Informal document Supplementing the Justification of ‘Proposal for Amendments to the 03 series of Amendments to UN Regulation No. 79 (Steering equipment)’ ECE/TRANS/WP.29/GRVA/2021/10

Submitted by the expert from the European Association for Electromobility**

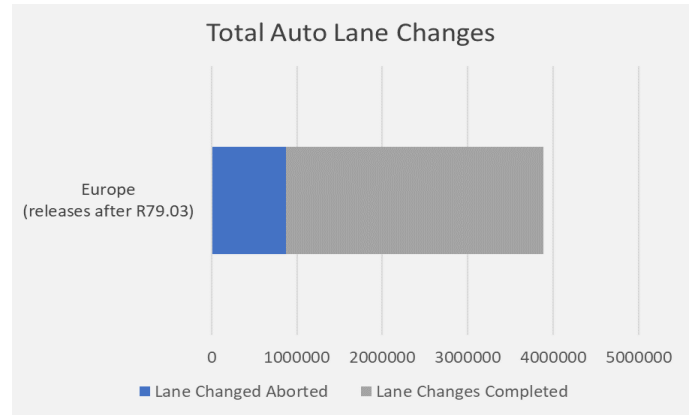
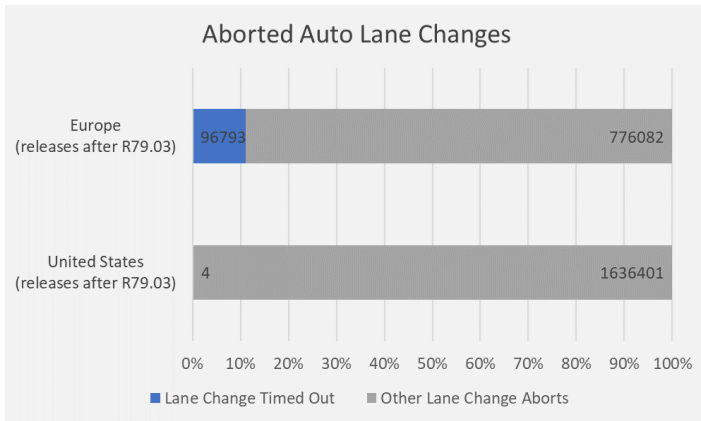
4. About 20% of lane changes performed in Europe result in aborts while such behavior is not present in the United States or other global markets that are not limited by the R79.03 requirements. Aborts are undesirable behavior and risks confusion of the driver or rear traffic. Data in graph below is collected in March 2021, equivalent to more than 20 million lane keeping miles across Europe (with R79.03), over a 100 million lane keeping miles in the U.S. (no R79.03).

5. Lane Change performance based on a manufacturer's customer fleet data between May and August 2019, around the time this manufacturer began complying with R79.03 requirements. Data represents around 9.6 million Lane Keeping kilometers across Europe in builds prior to R79.03, and around 9.6 million kilometers since R79.03. Data on graphs below represents around 66 million lane keeping kilometers in the U.S. in builds prior to R79.03, and around 71 million kilometers since R79.03 (though R79.03 restrictions do not apply in the US).
